April 16, 2003

**Re: GE-Pittsfield/Housatonic River Site
Floodplain Residential and Non-Residential Properties Adjacent to the 1½ Mile
Reach of Housatonic River (GEC710 and GEC720)
Response to EPA's April 9, 2003 Conditional Approval Letter for Phase 2, Group 2
Floodplain Properties**

GENERAL ELECTRIC COMPANY PITTSFIELD, MASSACHUSETTS
 FLOODPLAIN PROPERTIES ADJACENT TO THE
 1-1/2 MILE REACH
**SUMMARY OF PROPOSED
 SOIL SAMPLING LOCATIONS
 PHASE 2, GROUP 2**

FIGURE
4-3

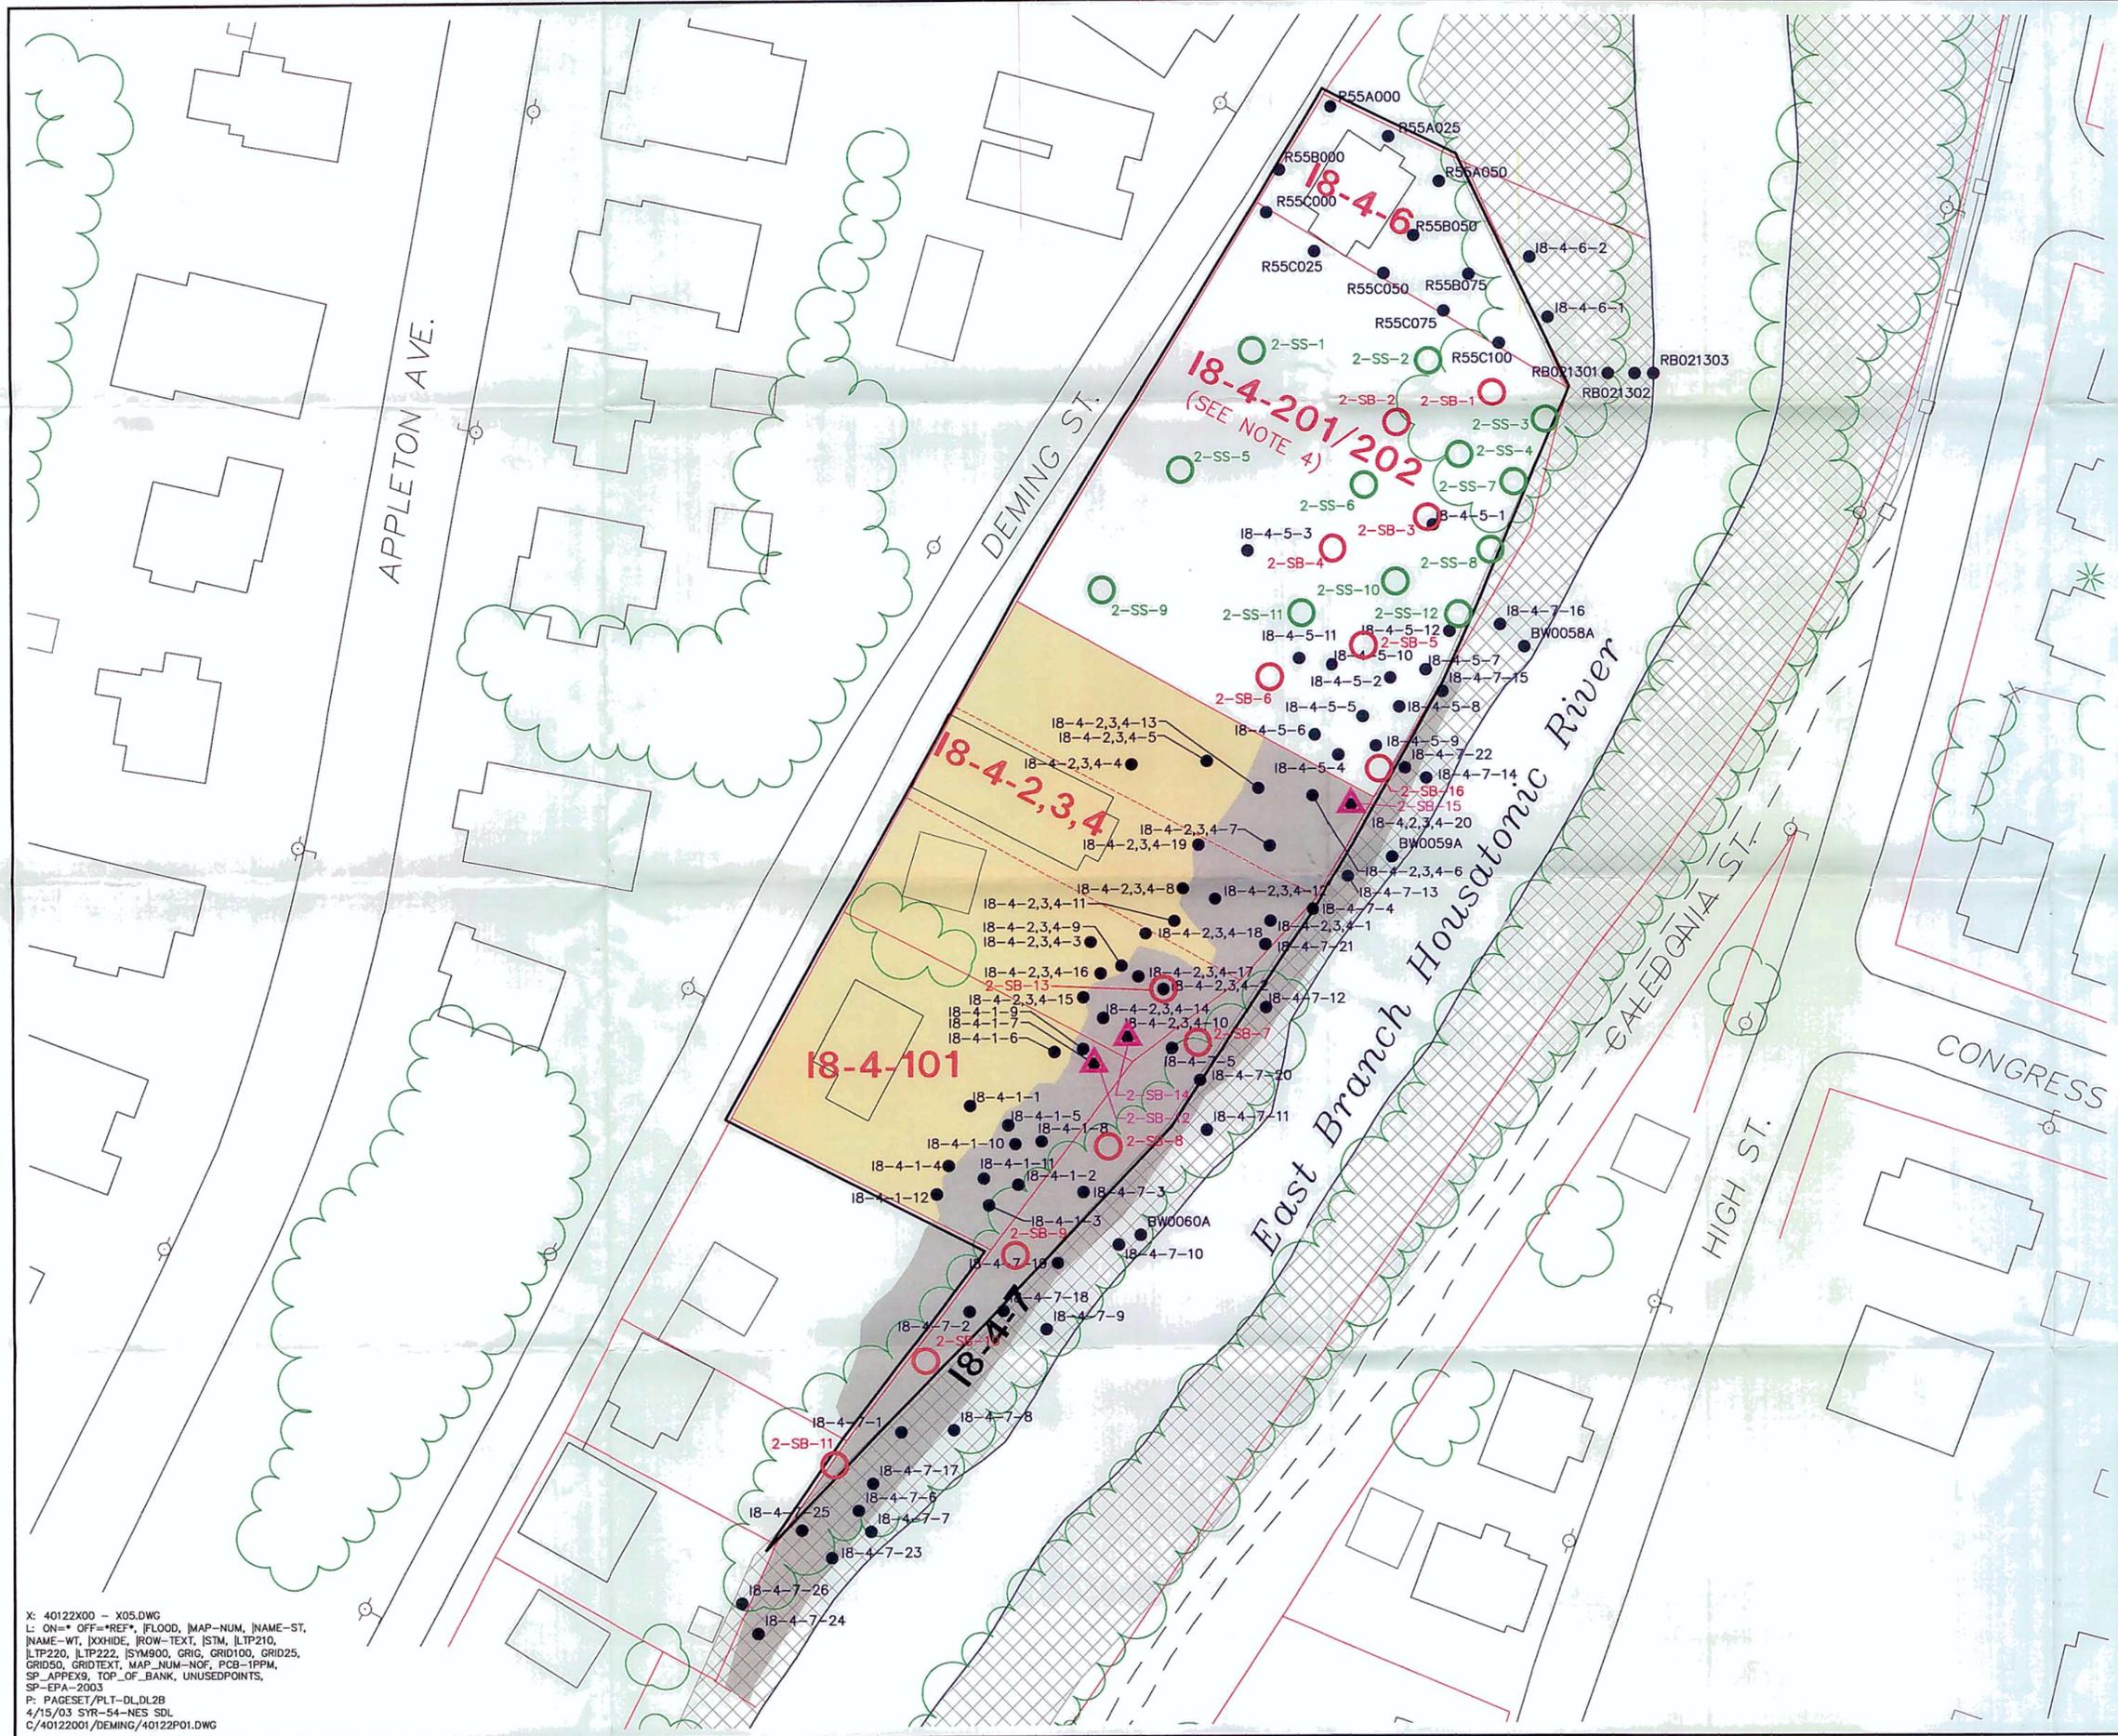
1. In Condition No. 2 of its April 9, 2003 conditional approval letter, EPA indicated that its project database has been updated since submittal of the PDI Work Plan, and it directed GE to update the appropriate data tables and figures for inclusion in the future Pre-Design Investigation Report for the Phase 2 properties. GE will incorporate this information into its future reports. Also, on a related matter, please note that a recent review of the City of Pittsfield Tax Assessors Records revealed that Parcel I8-4-1 has now been redesignated as Parcel I8-4-101. That new parcel number is shown on the attached figure.

2. EPA's Condition Nos. 3 and 5 require GE to perform additional soil sampling, beyond the sampling proposed in the PDI Work Plan, for certain properties in Phase 2 – namely, Parcel I8-4-101, Parcels I8-4-2, 3, & 4 (which comprise one commonly owned property), and Parcel I8-4-201/202.

The PDI Work Plan proposed to collect several surface and subsurface samples at this property. As required by EPA's Condition No. 5, GE will advance one additional boring on this property (2-SB-16, as shown on revised Figure 4-3) in the vicinity of several prior sampling locations to further assess the vertical extent of PCBs. Samples from this proposed boring will be collected from the same depth increments specified in the PDI Work Plan for the other soil borings on this property (i.e., 0 to 1 foot, 1 to 3 feet, 3 to 5 feet, 5 to 7 feet, and 7 to 9 feet), as shown in Table 1, and will be analyzed for PCBs iteratively consistent with the protocol identified in the PDI Work Plan for the other borings on this property (i.e., beginning with the uppermost three depth increments). Sufficient sample volume will be obtained to allow EPA's representative to obtain a split sample.

This letter addresses each of the conditions in EPA's April 9, 2003 conditional approval letter and presents a proposed schedule for the performance of initial pre-design investigations at these properties. In addition, we are attaching a revised Figure 4-3 showing the proposed (and existing) sampling locations at these properties, and a new Table 1 listing the locations of the proposed soil borings and the depths from which samples will be collected from those borings. The attached Figure 4-3 and Table 1 reflect both the investigations previously proposed for the Phase 2 properties in the PDI Work Plan and the additional sampling activities described below. Unless otherwise noted below, the procedures, protocols, and methodologies established in the PDI Work Plan remain unchanged.

diphenylhydrazine) (Appendix IX+3). Specifically, soil samples will be collected for Appendix IX+3 analyses from three of the proposed locations identified above: I8-4-1-7 (2-SB-12); I8-4-2,3,4-10 (2-SB-14); and I8-4-2,3,4-20 (2-SB-15). These samples will be collected from a 2-foot depth increment located immediately or very close beneath the previous depth of soil excavation at each location. Specifically, considering the prior soil removal depths at these locations, these samples will be collected from the 1- to 3-foot depth increment at location 2-SB-12, the 5- to 7-foot depth increment at location 2-SB-14, and the 4- to 6-foot depth increment at location 2-SB-15, as shown on Table 1.
